**Subject: Beaver Valley Power Station, Unit No. 1
BV-1 Docket No. 50-334, License No. DPR-66
Additional Information Regarding Responses to RAI Dated July 28,
2005 in Support of License Amendment Request No. 320**

UPDATED RESPONSES TO RAI QUESTIONS B.1 AND C.5

UPDATED RESPONSES TO RAI QUESTIONS 5 AND 6

Updated Response (*with changes from previous response provided in italicized bold type*):
Note, there were no changes to Table 5-2 or to the Figures 5-1 through 5-6. They are being provided for completeness.

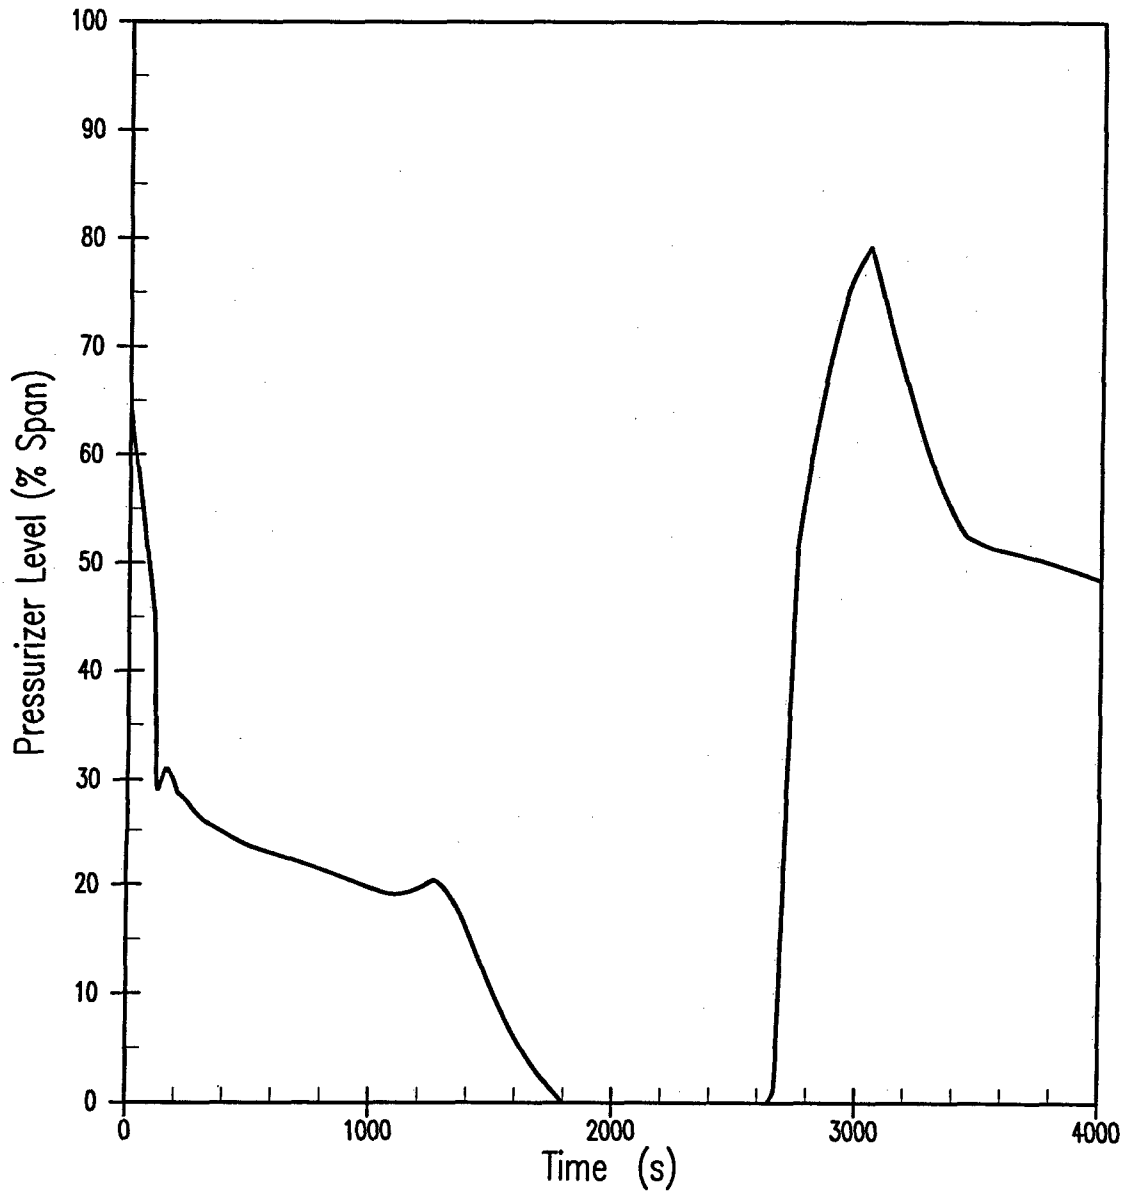
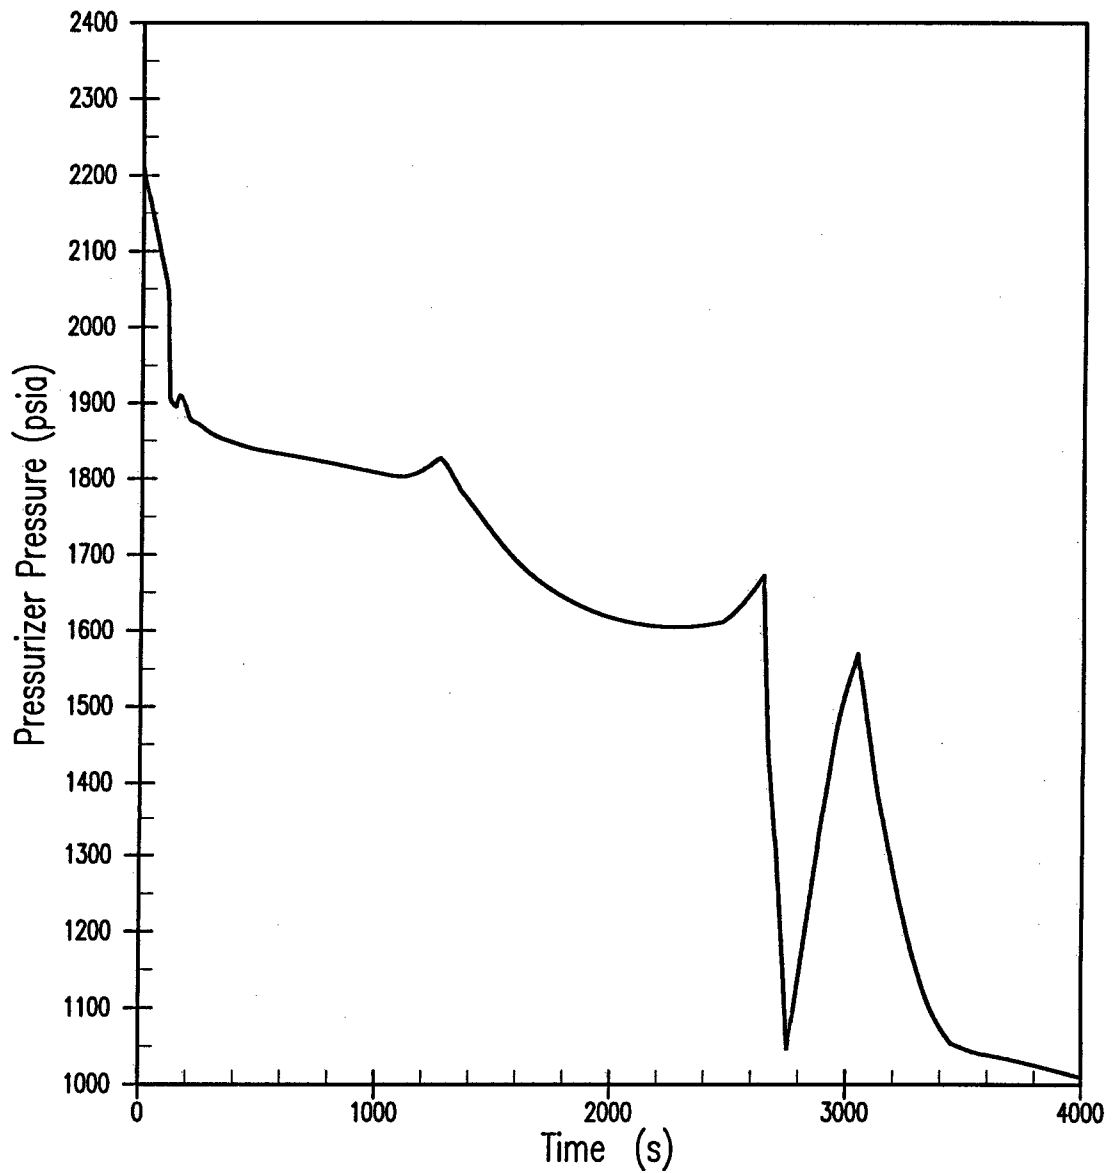
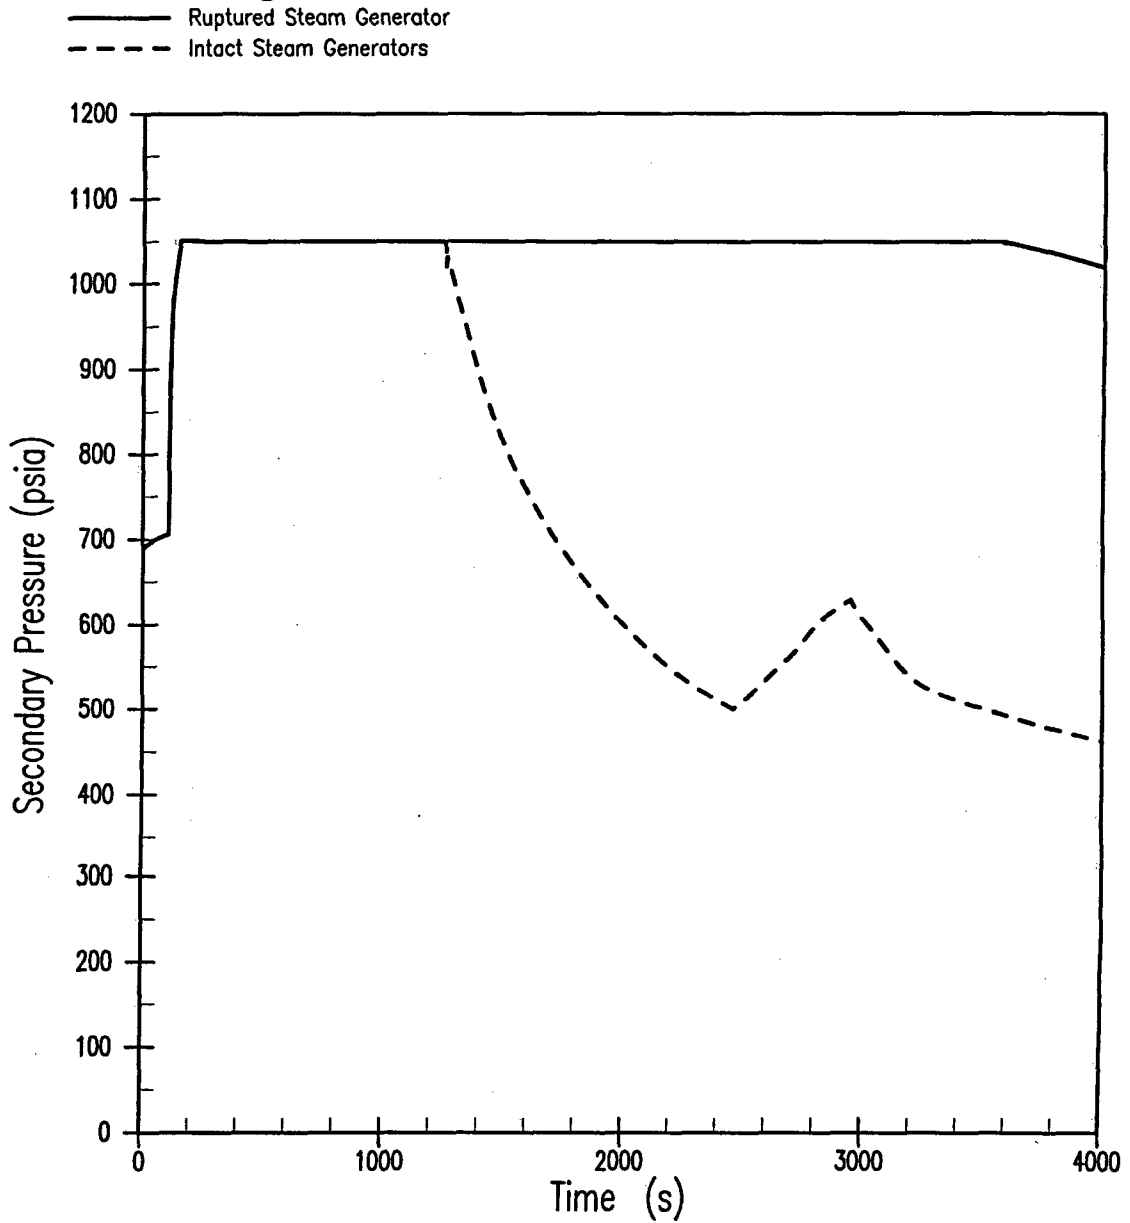
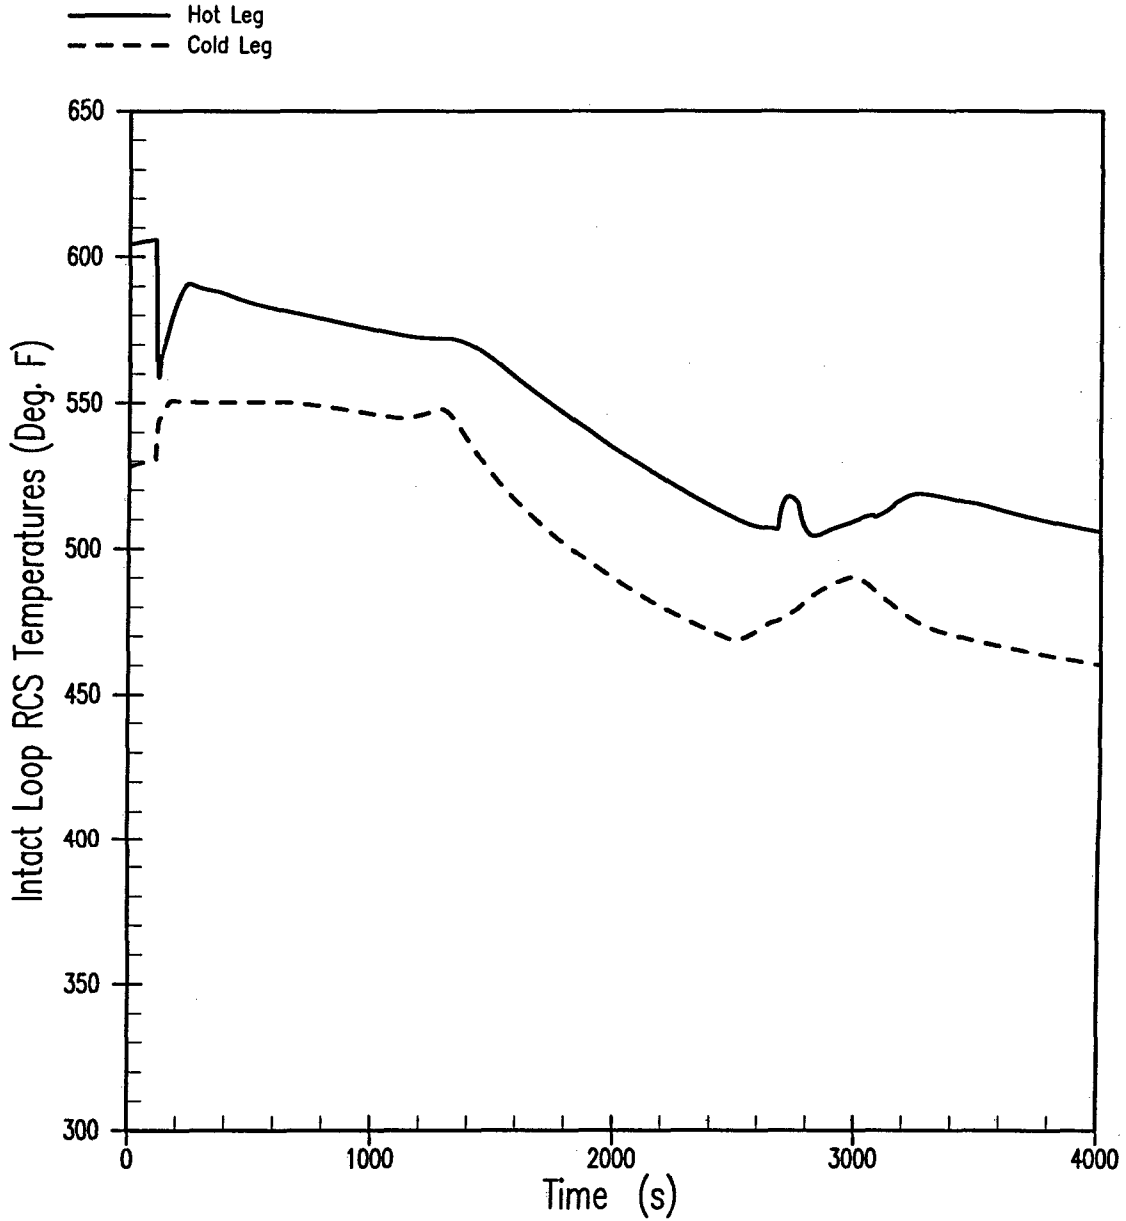
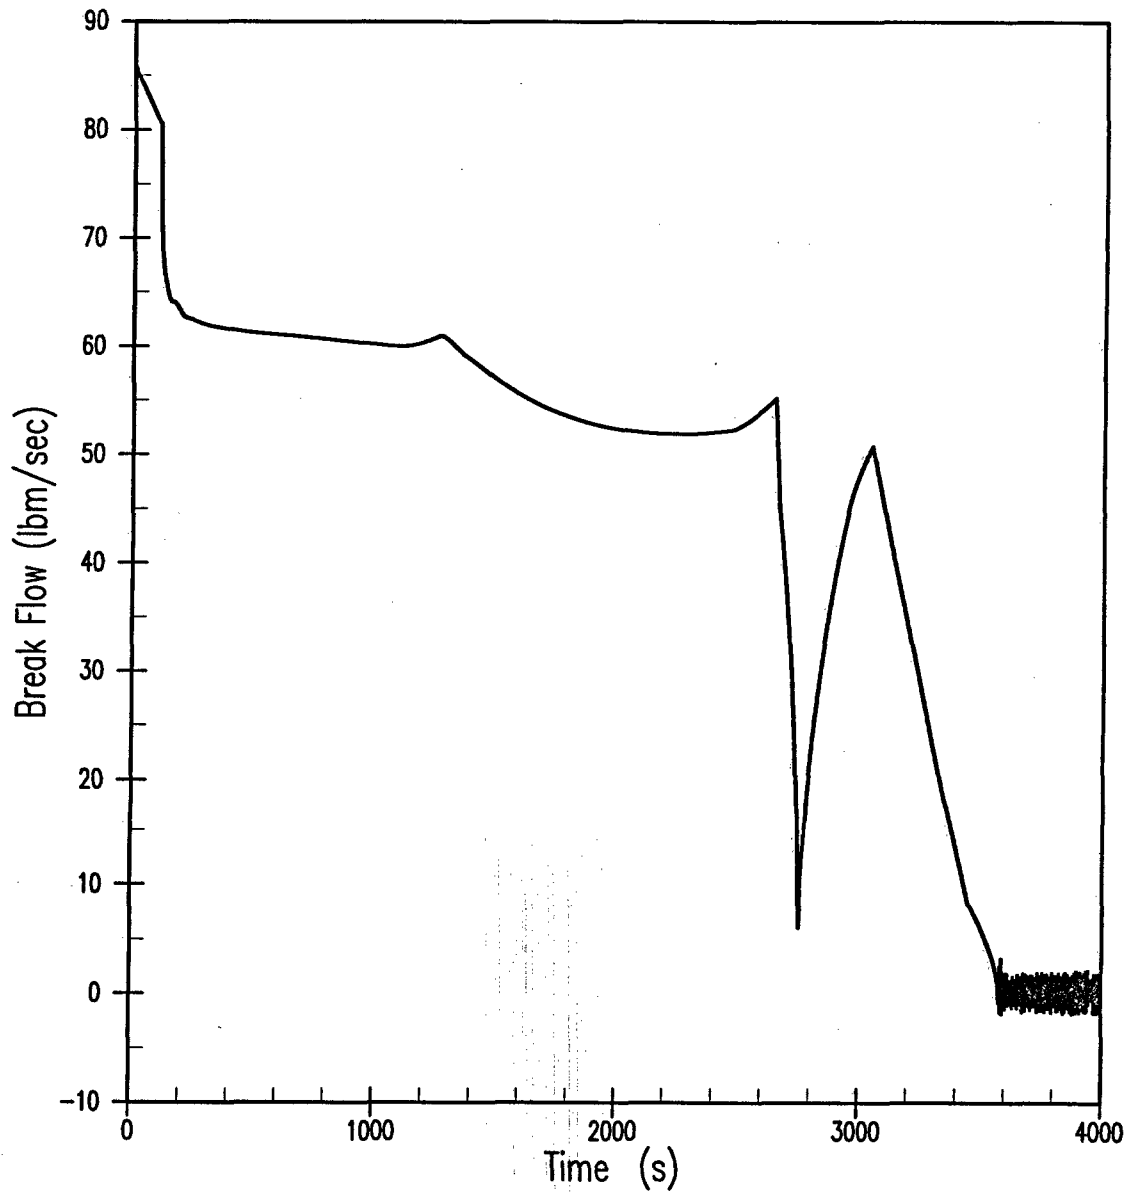
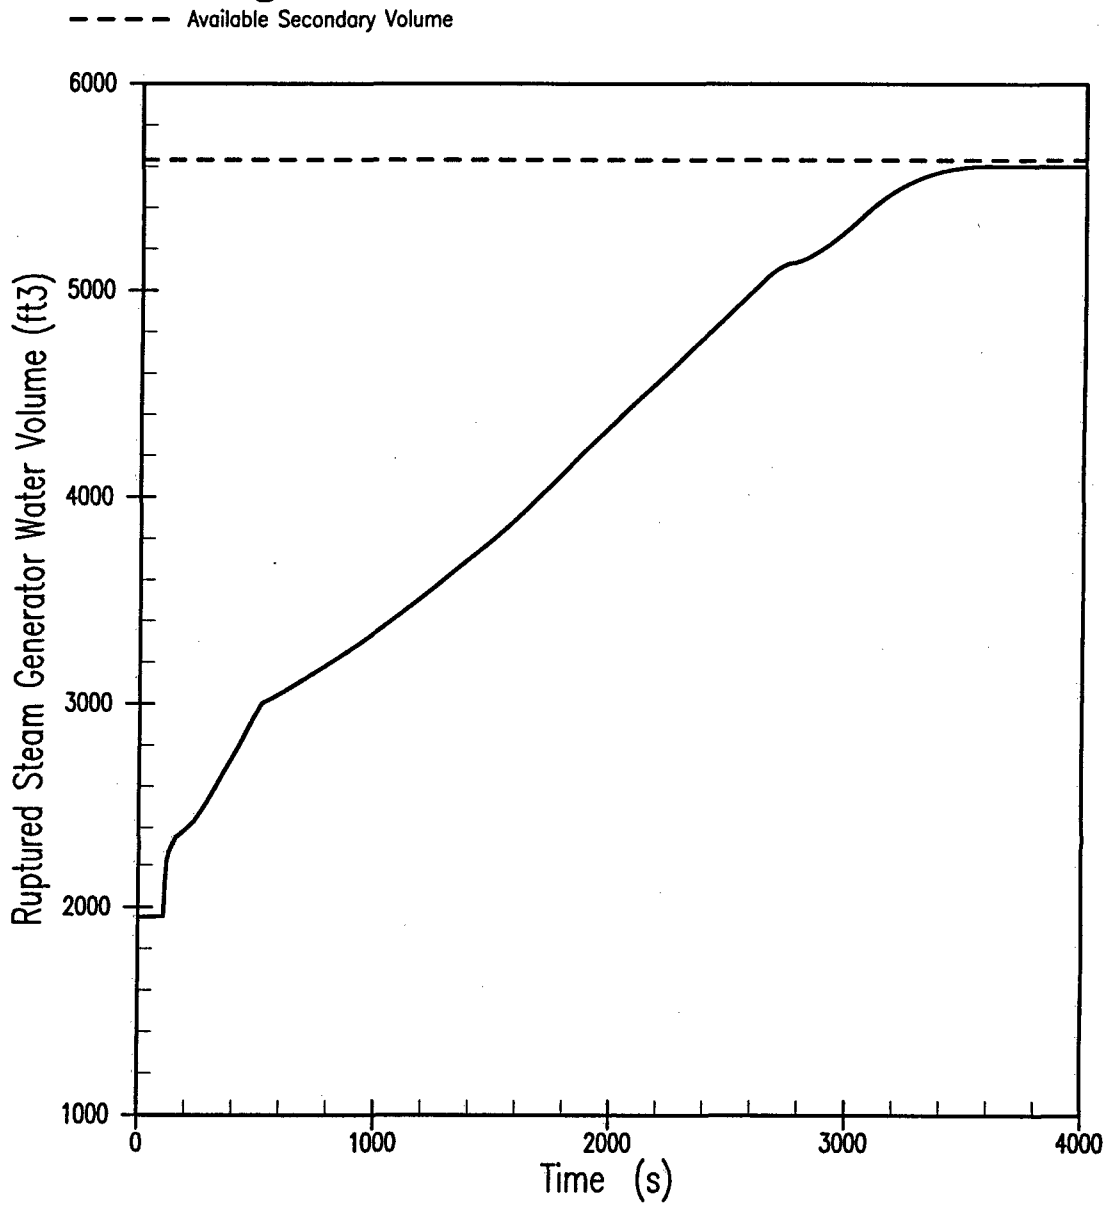
Section 5.4 of the April 13, 2005, RSG LAR states that an operational response analysis of steam generator tube rupture (SGTR) was performed for BVPS-1. The NRC staff requests that the licensee provide a table listing the sequence of events and times from break initiation to event termination that shows operators can terminate the break flow from the ruptured SG within 51 minutes of accident initiation for the SG replacement and extended power uprate (EPU) conditions. Additionally, the staff requests that the licensee provide the results of the SGTR thermal-hydraulic analysis over time showing the pressurizer pressure, intact and ruptured SGs pressures, and ruptured SG water volume for the analysis to demonstrate that no overfilling of the SG occurs.

The SGTR operational response analysis for EPU conditions with RSG included cases to provide thermal-hydraulic tube rupture data for use in radiological dose consequence analysis and for evaluation of margin to overfill. The sequence of events for these cases is shown in Tables 5-1 and 5-2, respectively. The sequence of events tables show that termination of the event (i.e., termination of primary-to-secondary break flow) occurs at **3988** seconds (approximately **66.5** minutes) and 3578 seconds (approximately 60 minutes), respectively, for EPU conditions with RSGs. ***For BVPS-1, the termination time used in the radiological dose consequence analysis was increased to allow additional operator action time for the operator to isolate the failed-open steam generator atmospheric dump valve (ADV) on the ruptured steam generator.*** Figures 5-1 through 5-6 show the response of pressurizer level, pressurizer pressure, intact and ruptured SG pressure, intact loop RCS temperatures, primary-to-secondary break flow, and ruptured SG water volume for the margin to overfill case. The response to Question 6 provides information regarding the analysis performed in the 1990's for current power conditions that established a break flow termination time of 51 minutes.
